**Zoning Map Amendment—Lots 2 & 3 Gary &  
Debbie Pink No. 3—TNT Holdings, LLC**

**Planned Unit Development Site Plan—Lots 2 & 3  
Gary & Debbie Pink No. 3—TNT Holdings, LLC**

**CITY OF LA VISTA  
PLANNING DIVISION  
RECOMMENDATION REPORT**

RE: Planned Unit Development – Initial Review  
TNT Holdings

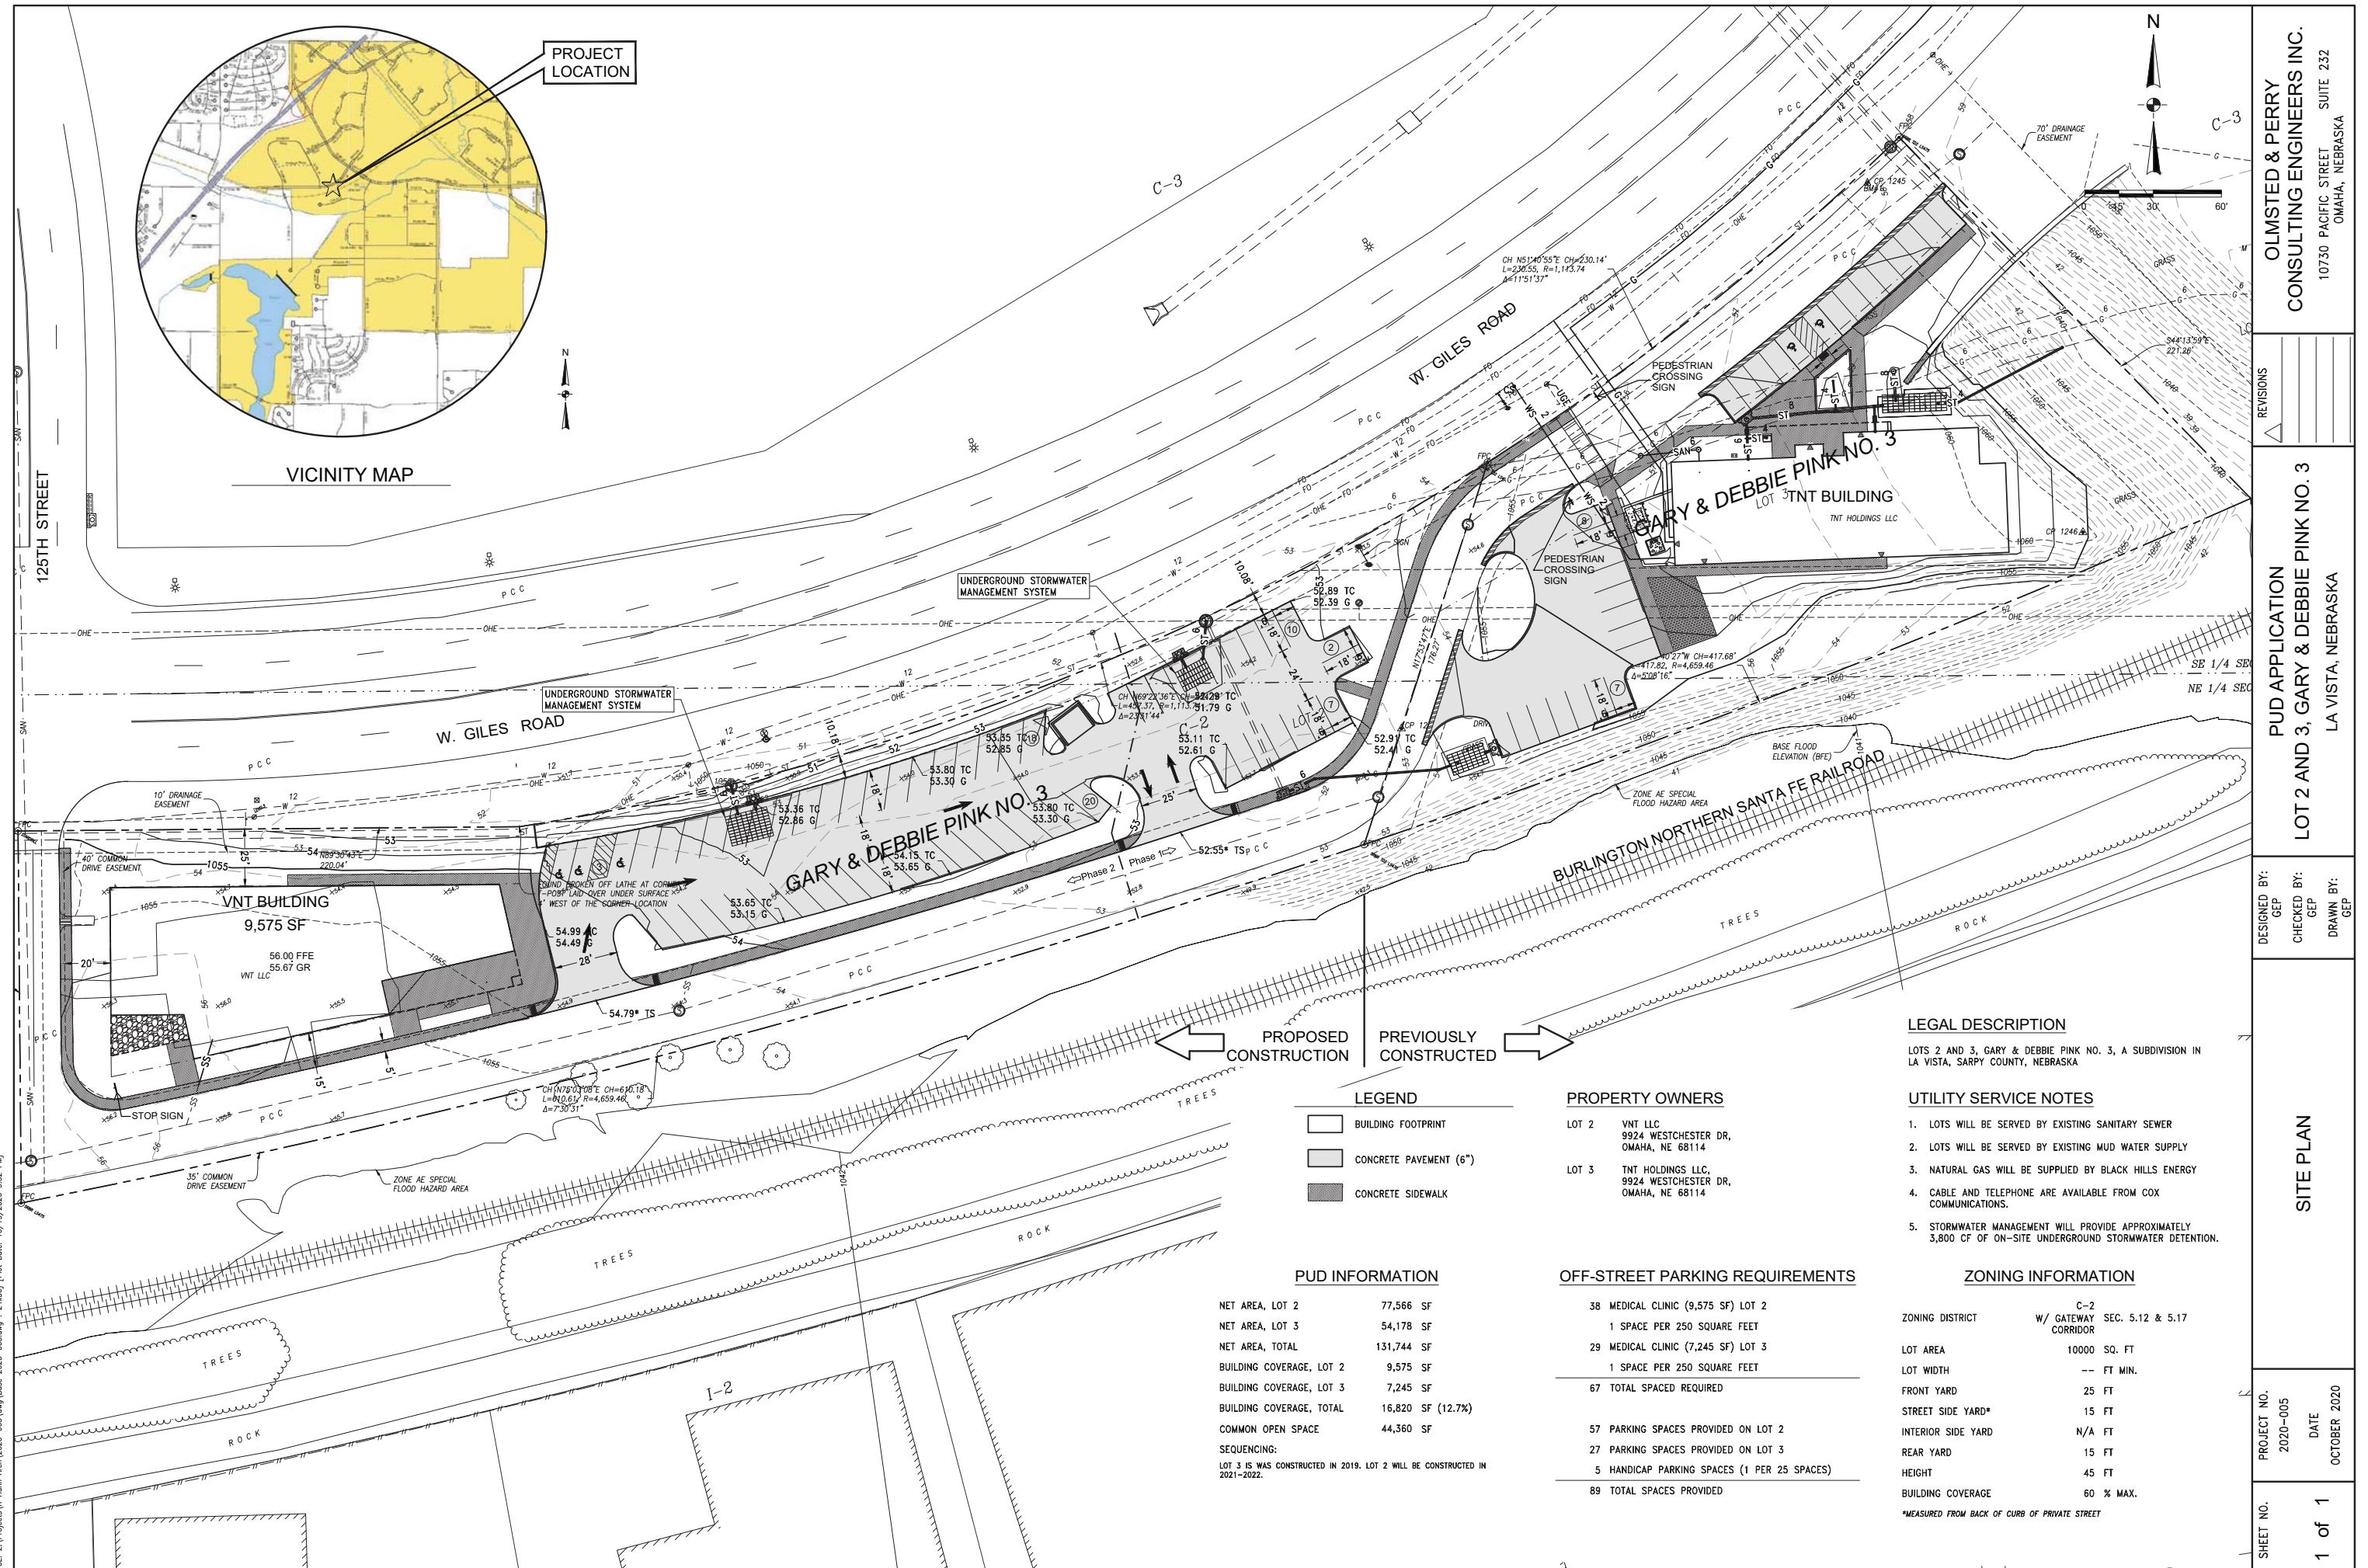
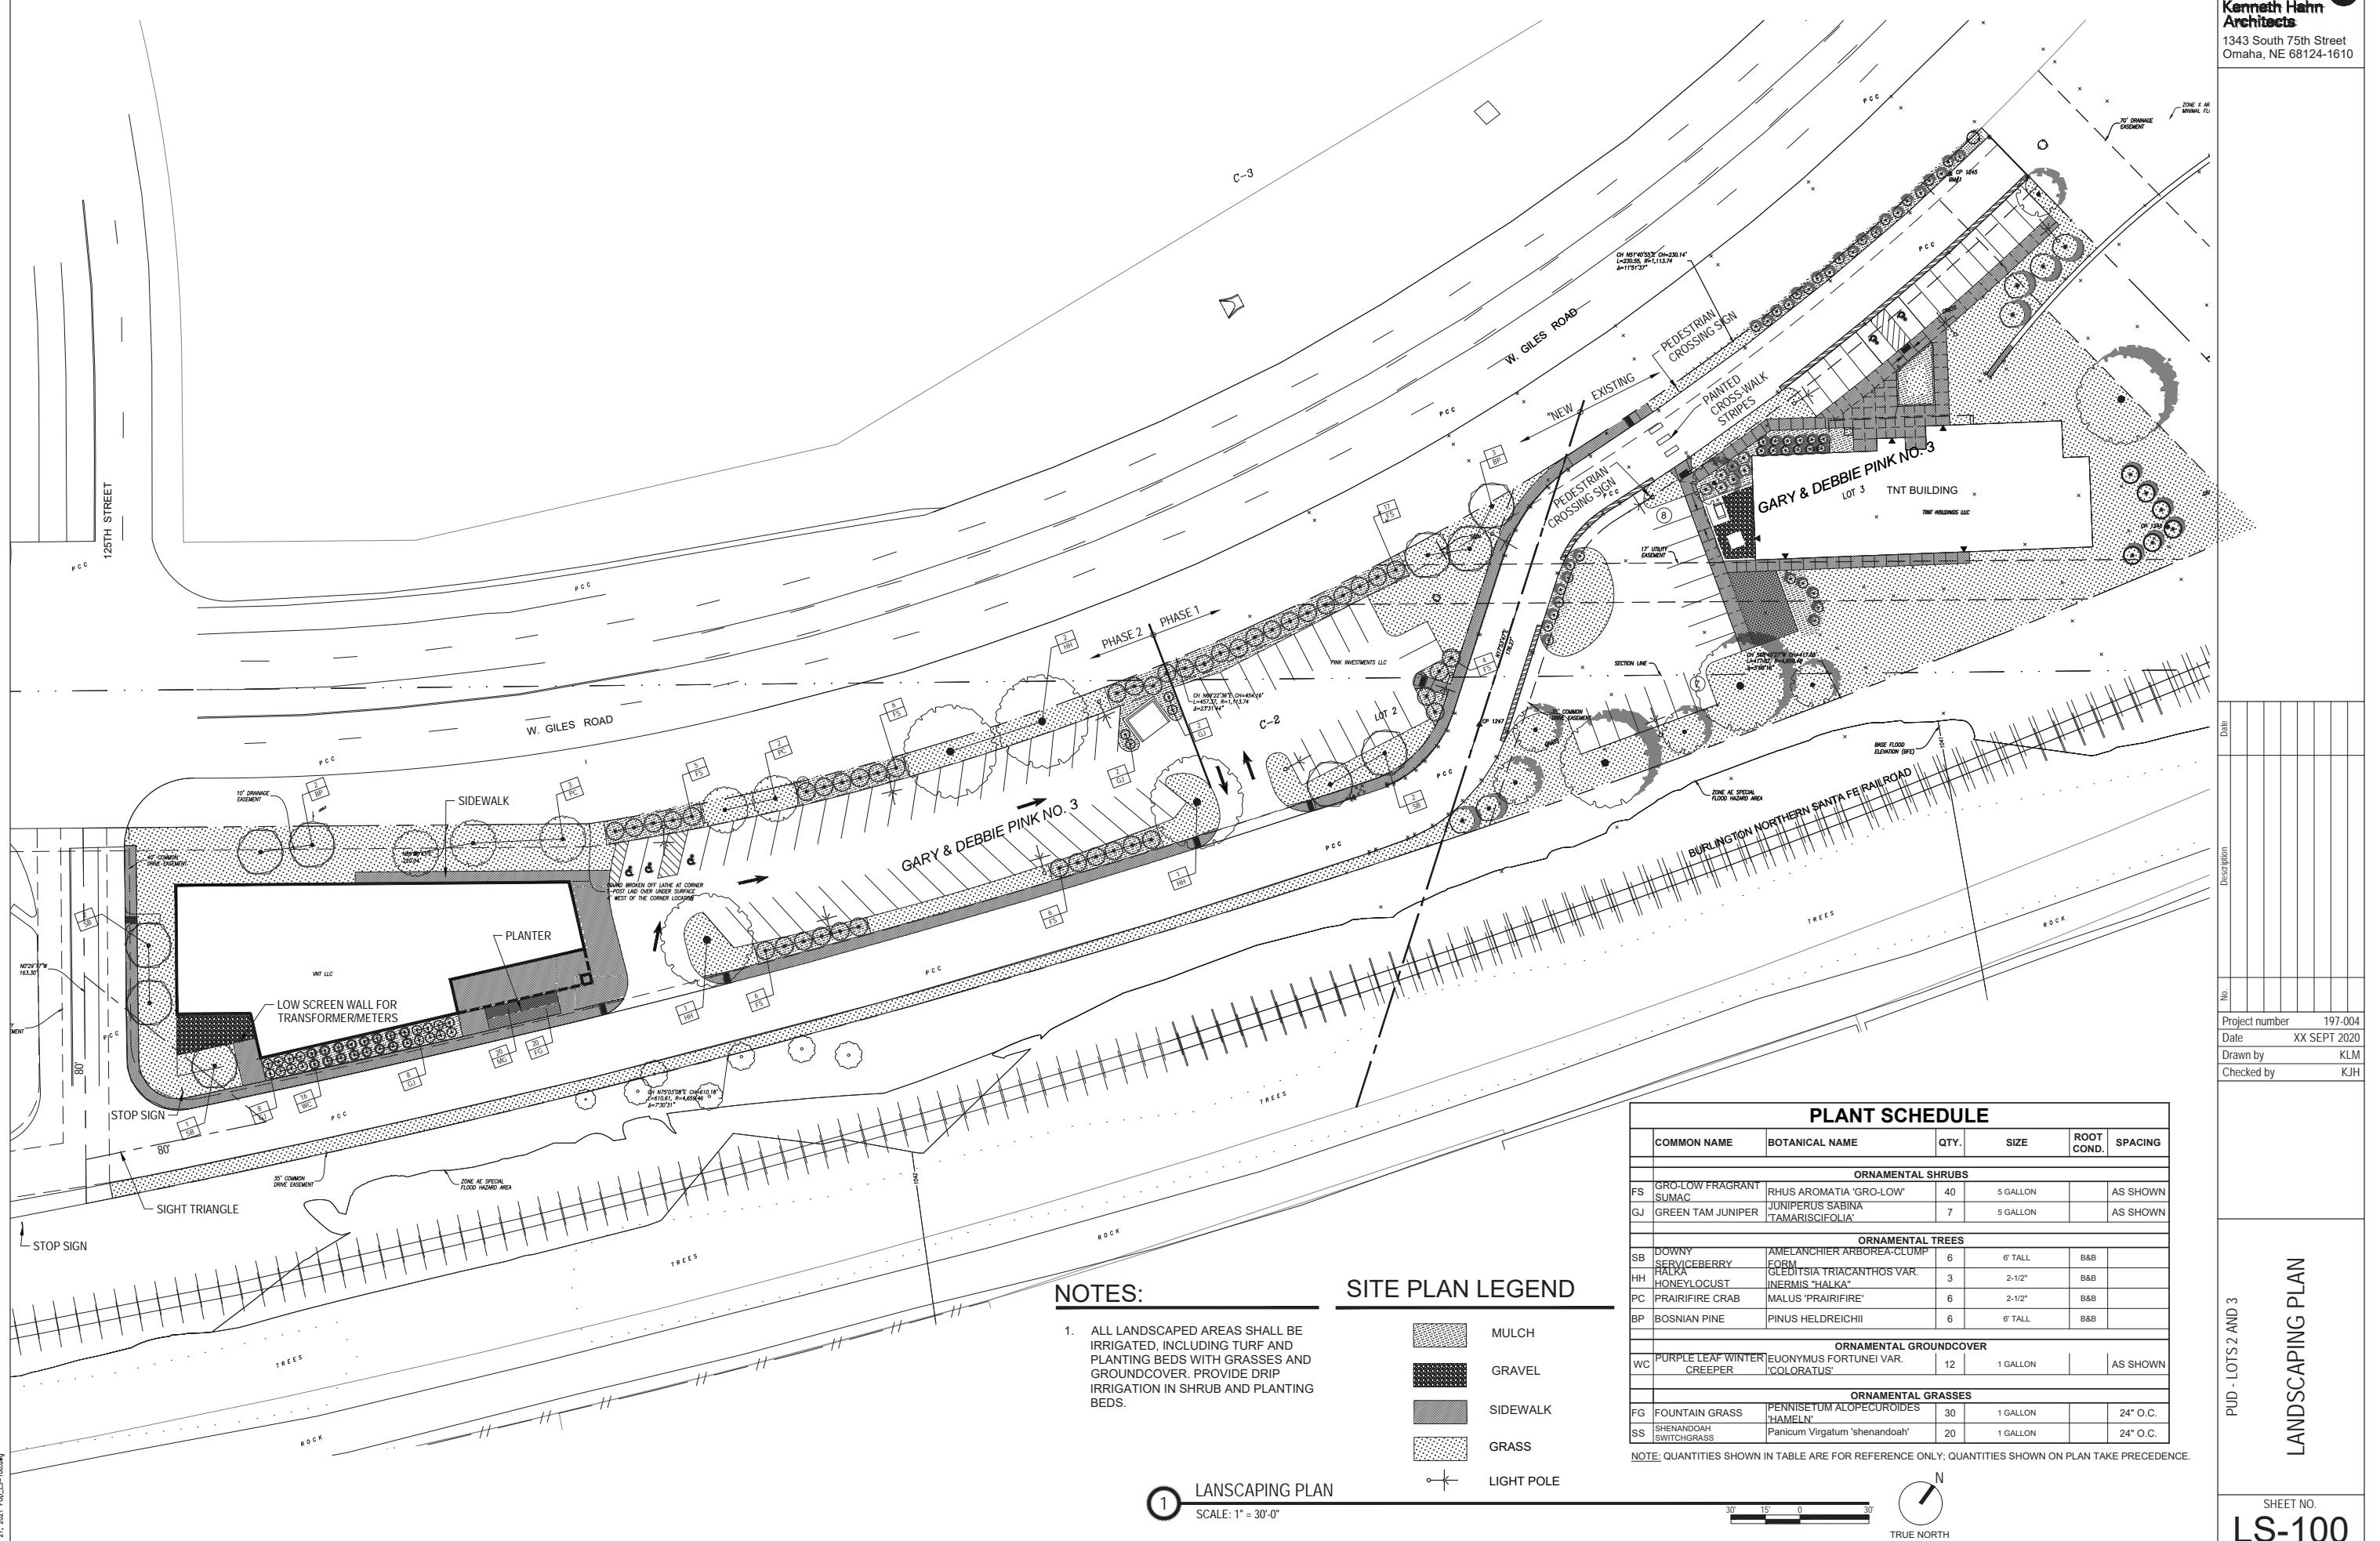
1. LS-100 Landscaping Plan:
  - a. See section 7.17.03.07 of La Vista Zoning Ordinance. All commercial office and industrial developments...shall provide perimeter landscaping to include a min. (1) tree for each forty (40) lineal feet of street frontage. Please verify and indicate on the drawing that the plan complies with this ordinance.

- b. See section 7.17.04.01 Screening Requirement of La Vista Zoning Ordinance. Parking areas abutting a public right-of-way are required to be screened from grade to a height of three feet. The trees and bushes indicated as a buffer between the public right-of-way and the parking are deciduous and will likely not have canopy to provide screening below 3 foot. Solid fences, walls, berms, hedges, shrubs, or evergreen trees are allowed by the ordinance. Please revise to show compliance with the ordinance.

- c. See Section 4, III, F, of the La Vista Gateway Corridor District Design Guideline. This guideline also requires natural undulating landscape forms. Avoid consistent straight-line plantings.

- d. See section 4, III, K. Storm water management is to be integrated into the site and landscaping. Please show how this will be integrated in your plan.
